Technical design note

Project name	Nestle Block B		
Design note title	Flood Risk response to LLFA		
Document reference	C-01669_TN-C-0100		
Author	GJ		
Revision	PO1		
Date	18 October 2023	Approved	☐

The purpose of this technical note is to provide clear responses and supporting information for Hillingdon Planning and Regeneration in regards to flood risk queries from the LLFA concerning Nestle Block B.

BLOCK B
PROPOSED CATCHMENT AREA

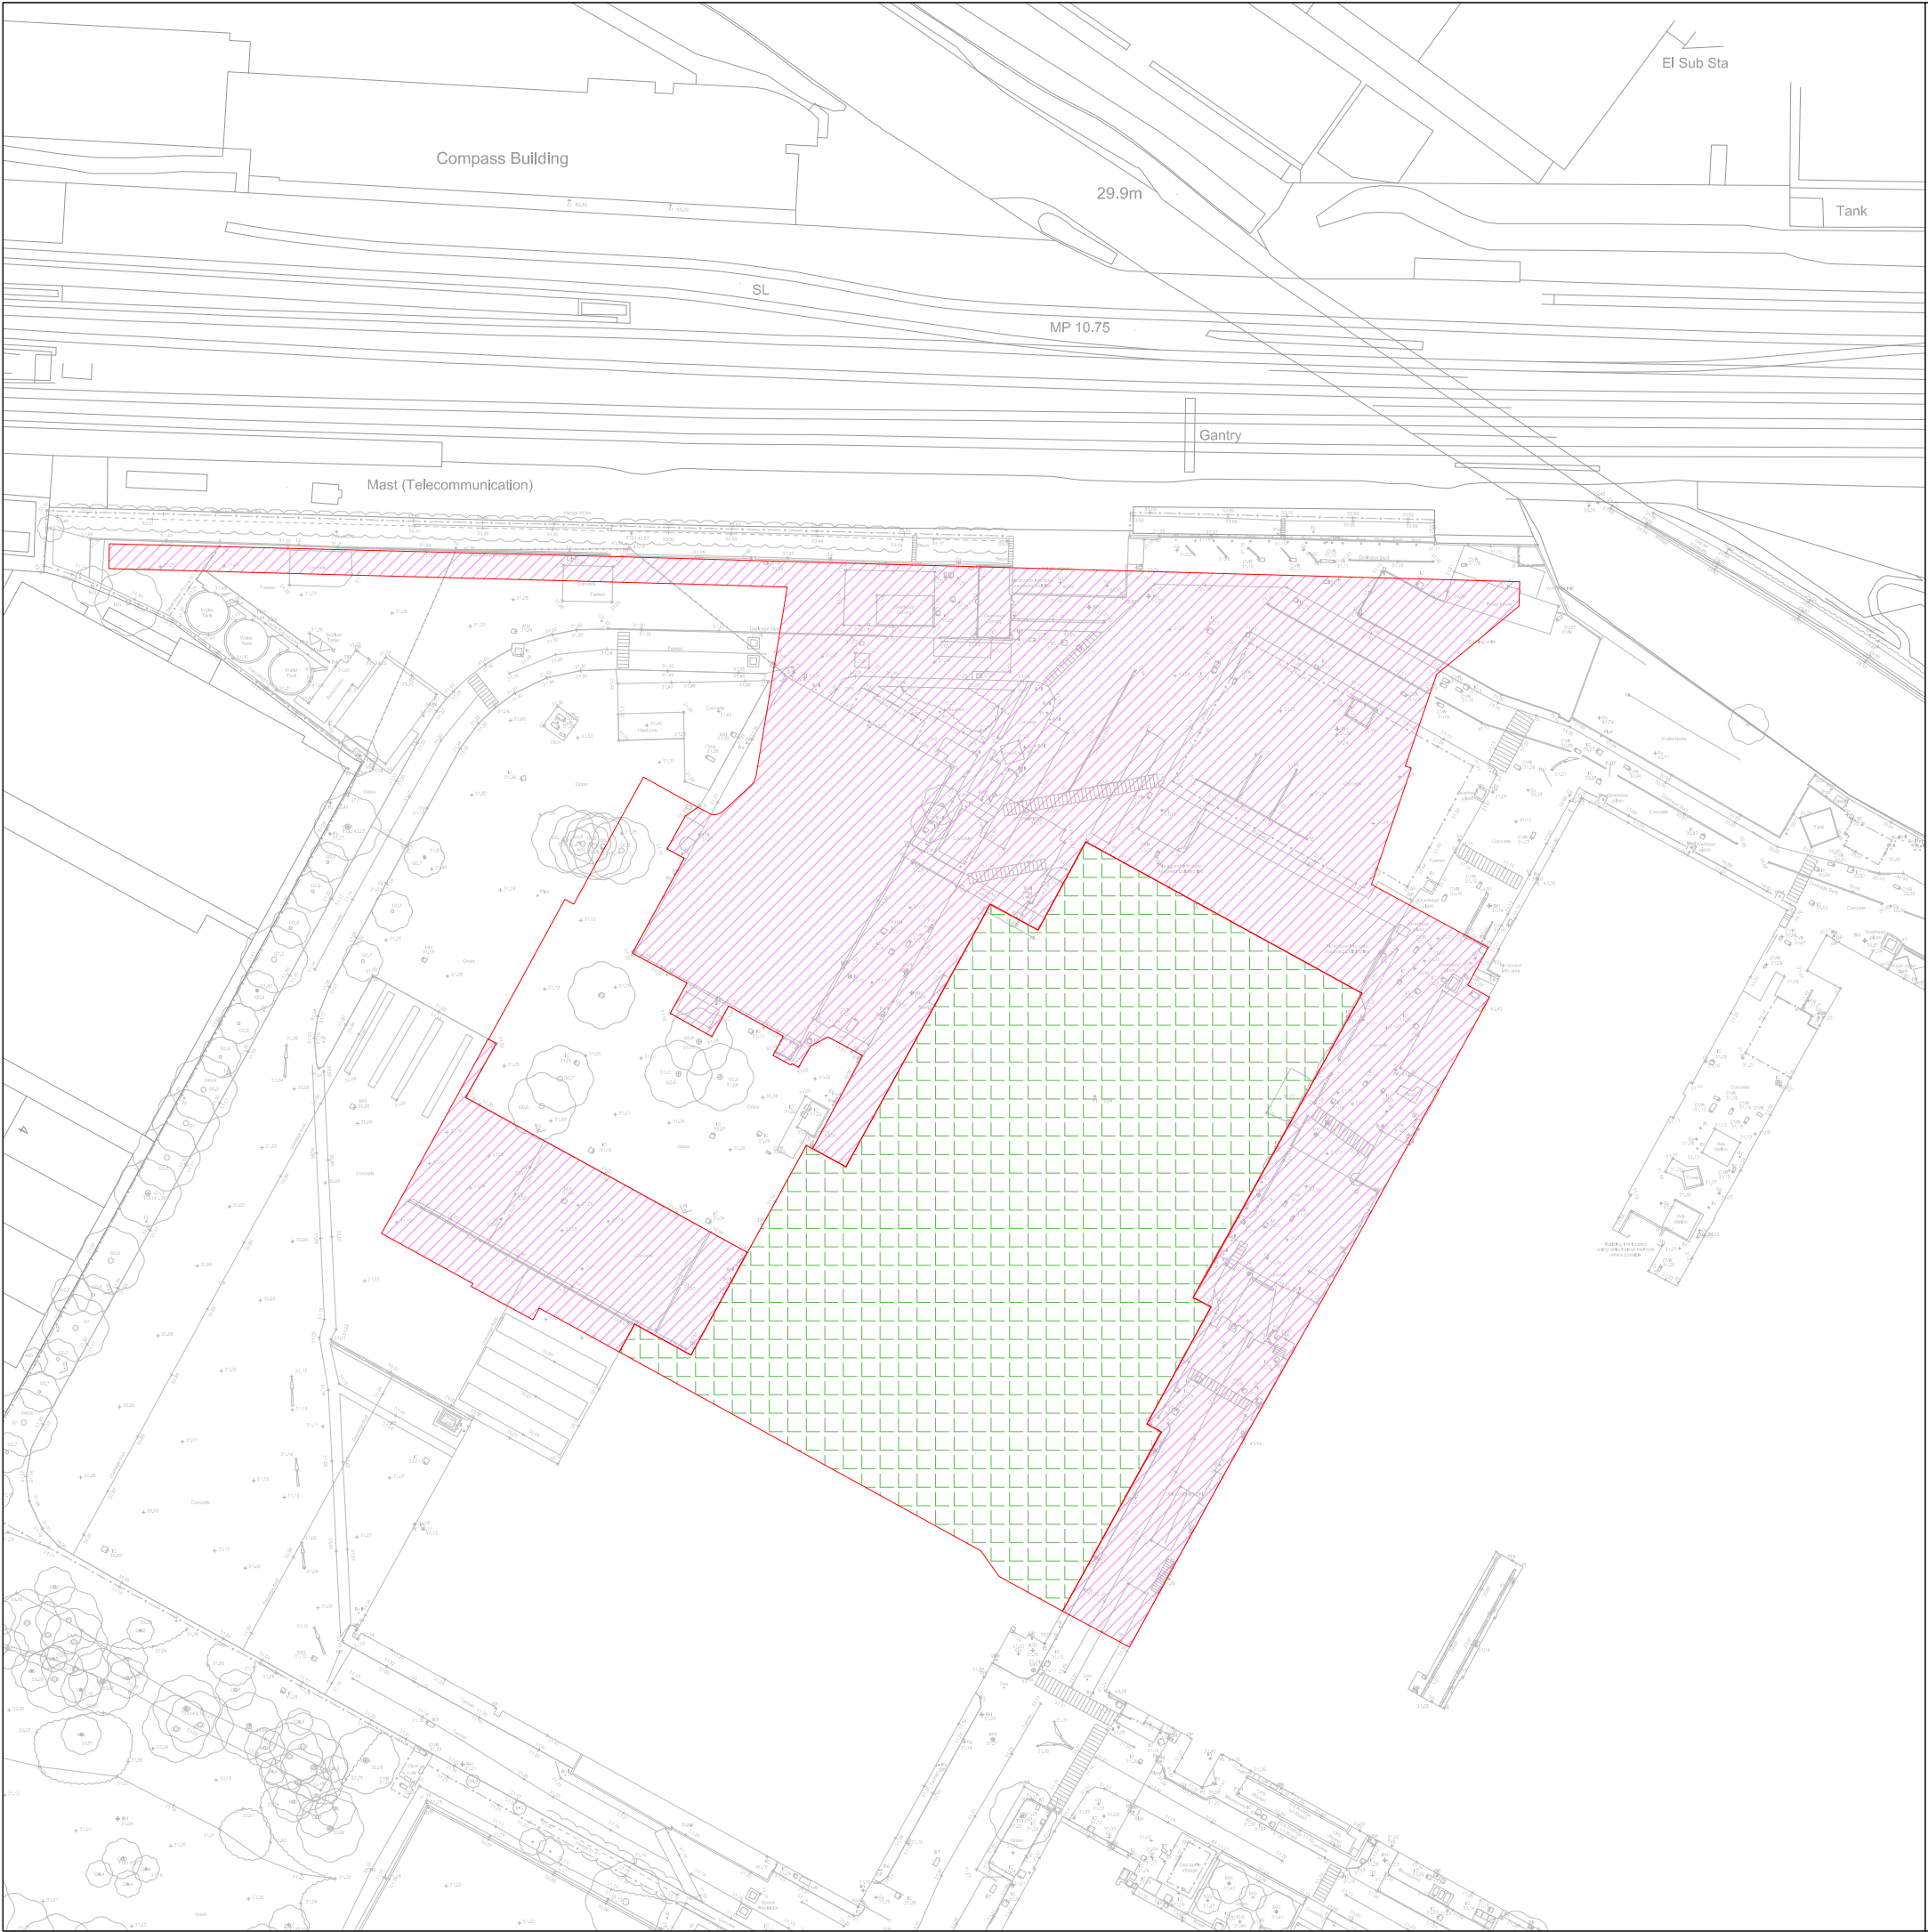
Confirm the total site area for Block B, including the existing and proposed impermeable area.

- The total existing impermeable catchment area within Block B site area is shown on drawing FNF-C-B-HYD-SK-01-902. Refer to Appendix B.
 - Hard standing area = 9,367m²
 - Building Area = 5,910m²
 - Total impermeable area = 15,277m²
- The total proposed impermeable catchment area within Block B site area is shown on drawing FNF-C-B-HYD-SK-01-901. Refer to Appendix A.
 - Hard standing area = 9,800m²
 - Building Area = 7,960m²
 - Total impermeable area = 17,760m²

Proposed Building Catchment Area = 9,800m²

Proposed External Catchment Area = 7,960m²

Total proposed catchment area positively drained within Block B site boundary = 17,760m²

5. Appendix C – Microdrainage Calculations

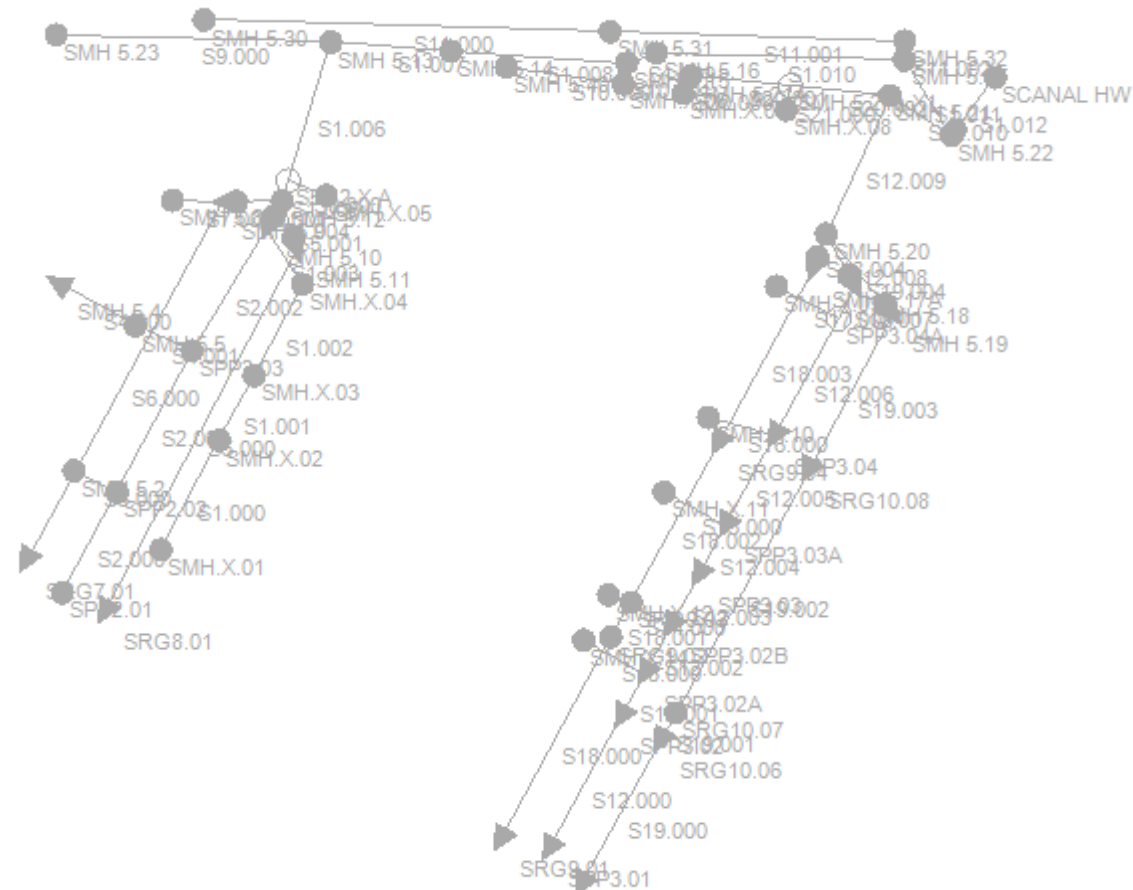
Show where the surface water network for Block B is included within the Micro-Drainage calculations, and confirms the drainage features and total storage volume provided for Block B.

- The MicroDrainage calculations in Appendix C has been annotated to show the total catchment area, drainage features and total storage provided below ground.

- Refer to Page 7 of the Microdrainage calculations to show a total external catchment area of 0.795 ha. This matches the Hard standing figure shown in Section 2.1 of this report, totalling 7,960m².

- The above ground drainage blue roof system has been designed by Alumasc. The restricted discharge rates for each outlet from the blue roof system designed by Alumasc has been entered into the microdrainage calculations under the Base Flow (l/s) column. Refer to page 7 reference and highlighted figures in the Microdrainage calculations.

TOTAL EXTERNAL CATCHMENT AREA ASSOCIATED WITH BLOCK B PROPOSED DRAINAGE

BASE FLOW QUANTITIES SHOW
CONTROLLED DISCHARGE RATES
FROM BLUE ROOF SYSTEM
ENTERING THE BELOW GROUND
DRAINAGE
